**STAFF REPORT:** 3/16/2022 SPECIAL MEETING

**ADDRESS:** 296 ELIOT

**APPLICATION NO:** #22-7663

**SCOPE:** REHABILITATE BUILDING

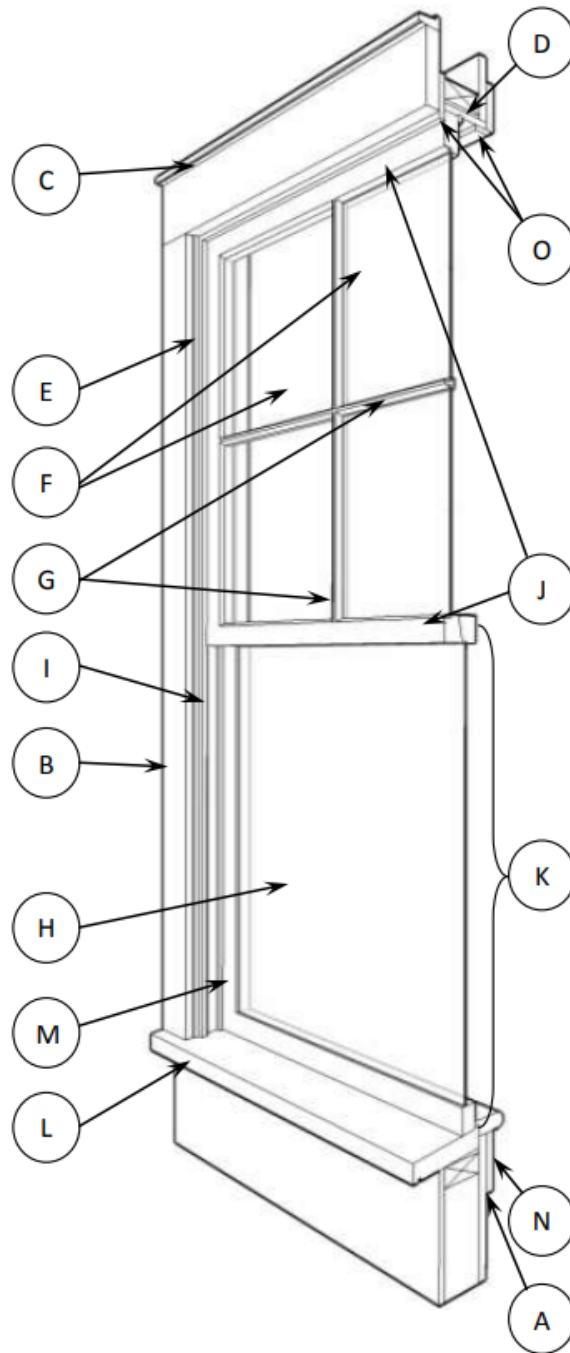
- Per the above Sanborn maps, the two masonry rear additions were erected prior to 1921 and are therefore over 100 years old. The rear brick additions remain as a tangible link to the City's period of rapid industrial expansion and associated population growth in the

early 20<sup>th</sup> century and the neighborhood's efforts to accommodate this influx of new residents. It is staff's opinion that these additions are significant, character-defining features of the property.

- As previously noted, it is staff’s opinion that the rear brick additions are character defining. The applicant proposes to undertake a number of alterations at the building’s rear, the majority of which will not significantly impact the historic character of the building. However, it is staff’s opinion that the proposed cement fiber siding installation will drastically/negatively alter the historic character of these additions as it changes the masonry expression of their exterior walls. The applicant has submitted a photo of the property next door which has a similar siding, but that building is not historic age/was erected in 2018. Staff recommends that the Commission **DENY** the addition of siding to the over the brick exterior walls of the building’s historic-age additions.

It is staff's recommendation that the Commission DENY the issuance of a Certificate of Appropriateness for the project as proposed new cladding to the rear additions' exterior walls, because it does not conform to the Brush Park Historic District's Elements of Design or the Secretary of the Interior Standards for Rehabilitation, in particular Standard# 2). *The historic character of a property shall be retained and preserved. The removal of historic materials or alteration of features and spaces that characterize a property shall be avoided*

**Current condition. Note that 2001 rehab resulted in the replacement of the brick sill with wood trim and the installation of 3, double-hung windows.**

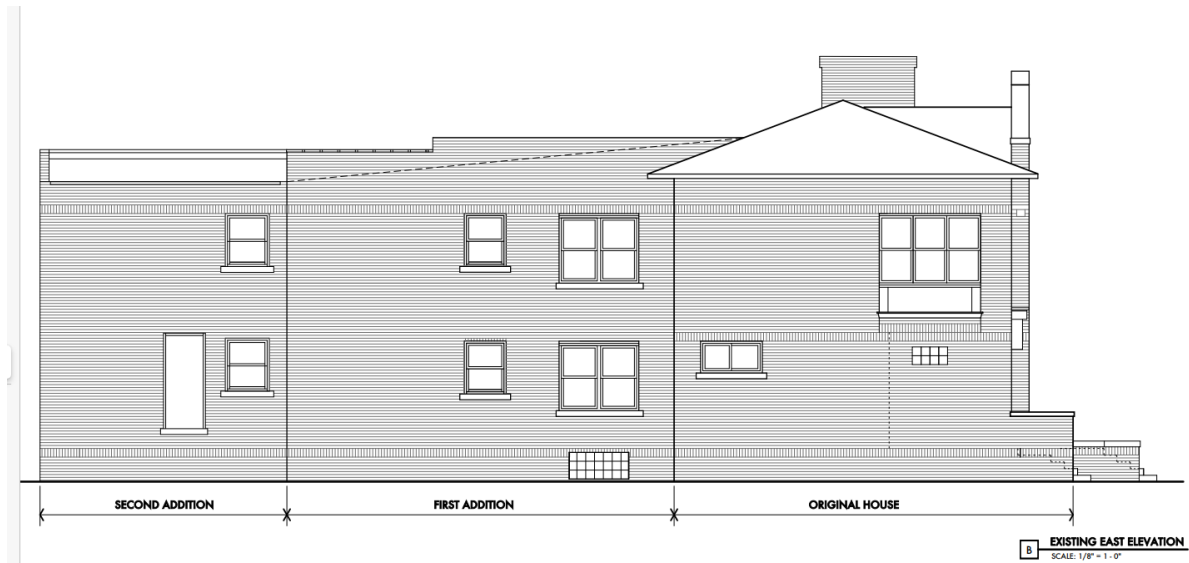
- See the below photos. Re: the northernmost window opening at the second story, east elevation, the applicant is proposing to remove the existing windows, trim and wood panel below to create a large window opening with 3, 1/1 mullied units. It is unclear if these windows will be fixed or double hung. It is staff’s opinion that the proposed introduction of large 1/1 windows at this location is inappropriate as it is unlikely that the proposed matches the original window configuration. As the original configuration is unknown, staff recommends that the size, light configuration, and operation of the current windows be maintained and that the area below, which is currently enclosed with wood panel, be infilled with brick and the current decorative stone sill be maintained at its current location.

**Condition in 2000. Note that this location included 4, double-hung, mullioned windows within this opening. There is a brick sill with an opening below that is infilled with wood paneling. Also, note location of historic/original stone sill**

- The new window proposed for installation at the northernmost window opening at the second story, east elevation, shall maintain the size, light configuration, and operation of the current windows. The area below the windows which is currently enclosed with wood pane and trim, shall be infilled with brick and the current decorative stone sill be maintained at its current location.

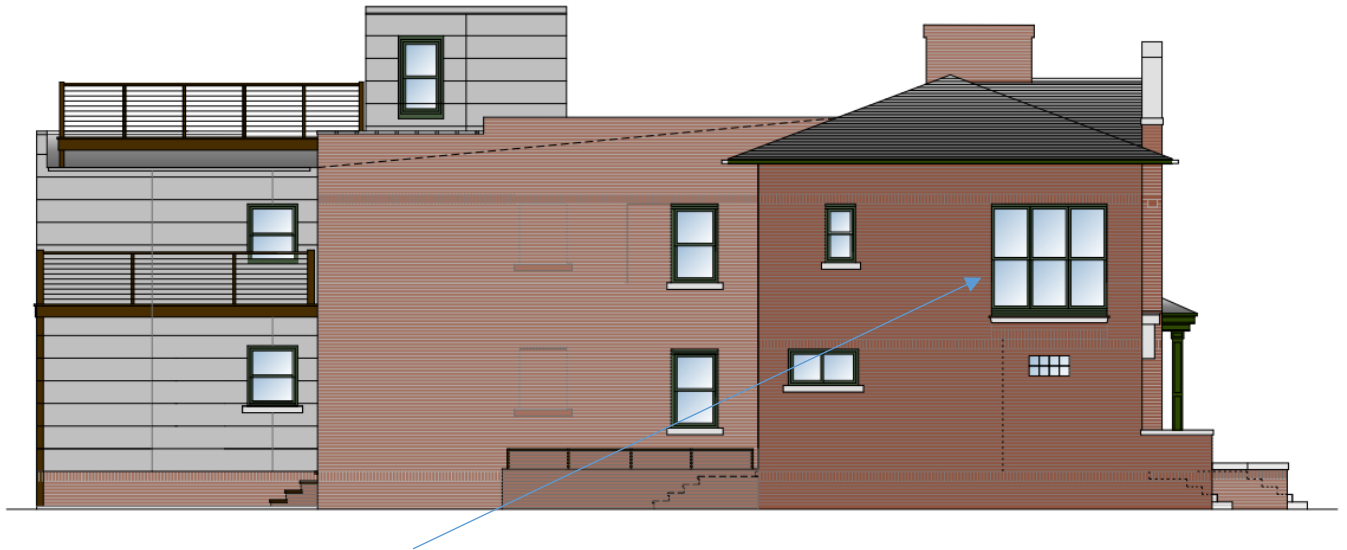
**Drawing, proposed condition. It is unclear to staff if these windows are fixed or double hung. Staff does not recommend that fixed windows be added at this location. Also, note the large size of these windows which will result from the removal of the existing windows, trim, and wood enclosure beneath the original window opening. It is staff's opinion that these windows are too large. Any new windows should be installed within/confined to the original opening size**
